**DEVIATION REQUEST
AND DECISION FORM**

Project Name : Circle K at Highway 24 & Meridian Road
 Schedule No.(s) : 5312402016, 5312403003, 5312403004, 5312402015, 5312405003, 5312404003, 5312405005
 Legal Description : Rezoned and replated land. See SDP submittal for full legal description.

CIRCLE K AT HIGHWAY 24 & MERIDIAN
 INTERSECTION DEVIATION EXHIBIT
 MAY 2024

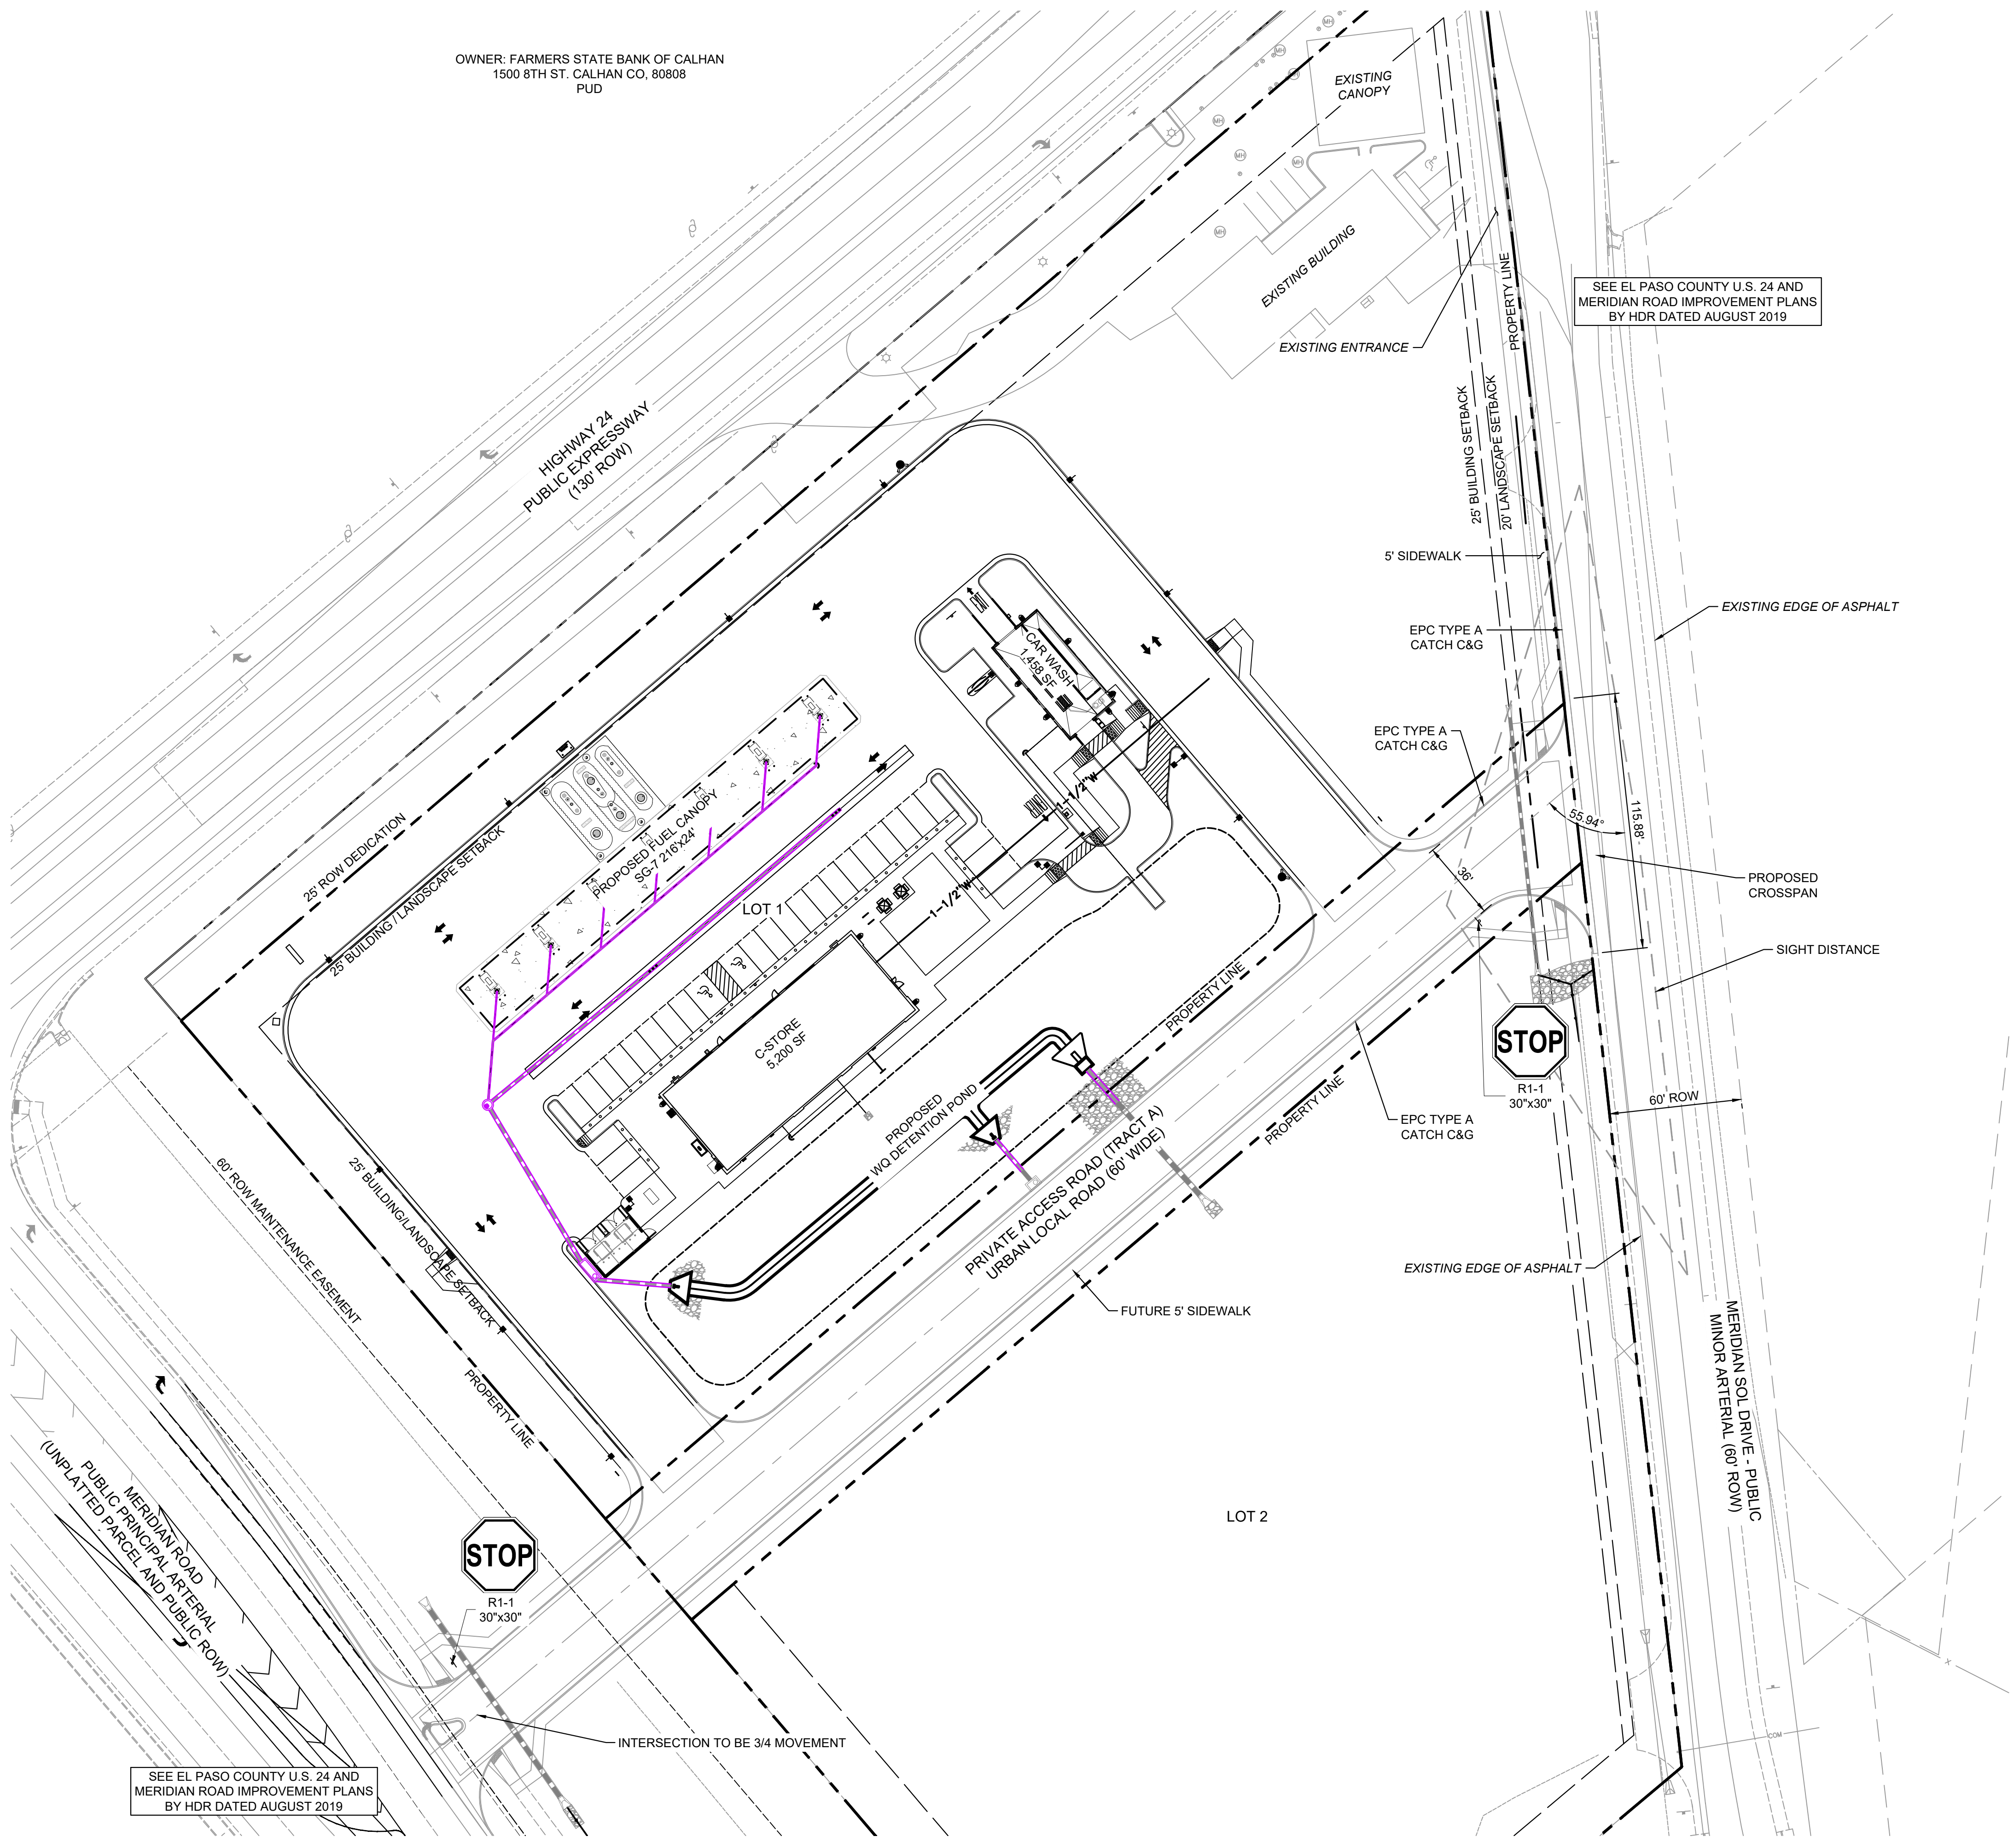
An intersection angle less than 90 degrees is necessary in order to fit within the lot/tract lines already established with the 1888 plat.

The proposed alternate design includes a private access road connecting to the existing Meridian Sol Drive at a 60-degree angle. The design has a 116 ft cross pan, underground culvert and pedestrian ramps for the proposed sidewalk along Meridian Sol Drive. The private access road connects to Meridian Road to the west at a 90-degree angle and both exits from the private access road have stop signs. The private access road speed is proposed to be 25 mph.

The proposed private drive on the southern border of the site is being proposed in order to fit within the existing ROW as established in the 1888 plat. This portion is being revised into a private tract but the existing linework is to remain as currently platted. This alignment creates a less than 90-degree angle at the intersection of the private access road and the existing Meridian Sol Drive. Given the 60' width of the proposed Tract A (existing public ROW) and the required urban local roadway section, we are unable to adjust the geometry of the roadway in order to intersect Meridian Sol Drive at a 90-degree angle.

The intersection design proposed shows an acute angle that could impact the visibility of traffic traveling northbound. To allow this intersection to function with the safety of a 90 degree intersection, the stop sign on the private access road will be set back closer to the PCR of the eastbound lane of the private access road. Sight visibility triangles will start at this location rather than near the flowline-flowline intersection as typically seen. This will allow drivers to stop safely before the intersection and have full visibility of traffic traveling northbound or southbound on Meridian Sol Drive and create intersection functionality identical to that of a 90-degree angle.

This request has been determined to have met the criteria for approval. A deviation from Section 2.4.1.C of the ECM is hereby granted based on the justification provided.
